<p><b>DOCKET NO. 435 - The Connecticut Light &amp; Power Company</b> }</p> <p>Application for a Certificate of Environmental Compatibility</p> <p>and Public Need for the Stamford Reliability Cable SRCP, }</p> <p>which consists of construction, maintenance, and operation of a</p> <p>new 115-kV underground transmission circuit extending }</p> <p>approximately 1.5 miles between Glenbrook and South End</p> <p>Substations, Stamford, Connecticut and related substation</p> <p>improvements.</p>	<p>Connecticut</p> <p>Siting</p> <p>Council</p> <p>August 2, 2013</p>
---	---

**DRAFT**

**Findings of Fact**

157. The calculated magnetic fields ~~on~~ along Lincoln Avenue (facing West) are shown in the table below.

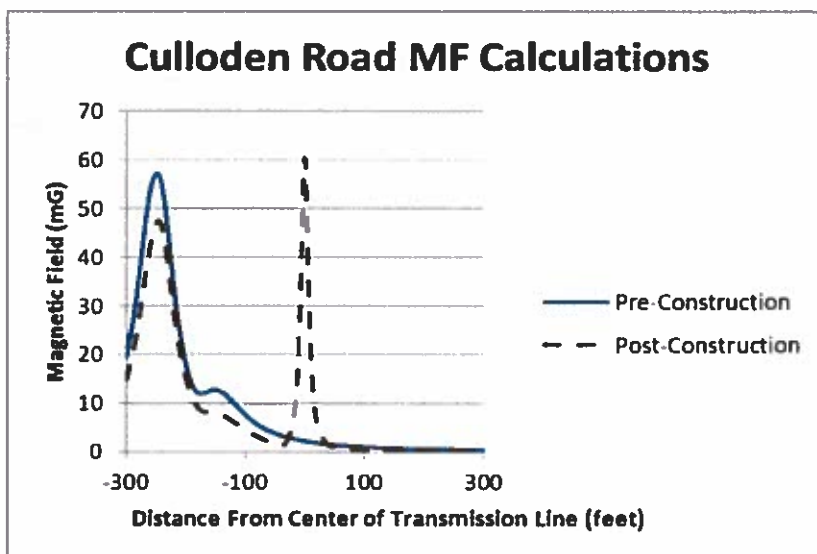
Comment: The revisions to DFOF ## 157 through 159 are intended to mirror the captions in the Application for these Figures for the MF calculations.
